## Field Service Bulletin Trucks

SB-10043764-4950
 Date
 Group
 No.
 Release
 Page

Combustion Air Valve and Piping Arrangement

# FSB 258-013, Combustion Air Valve and Piping Arrangement

W2071783

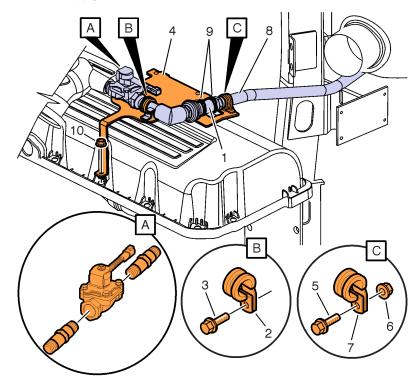
On the LEU and MRU model vehicles it has been determined that there was insufficient support of the combustion air valve and piping. Piping threads, are thus being stripped. A new clamp and mounting bracket has been designed and implemented in production in January 2009. The parts listed in this bulletin can be used to retrofit the EMCON valve support on older models to the current production level.

10 Install the new stand-off bracket (21257163) over the valve cover.
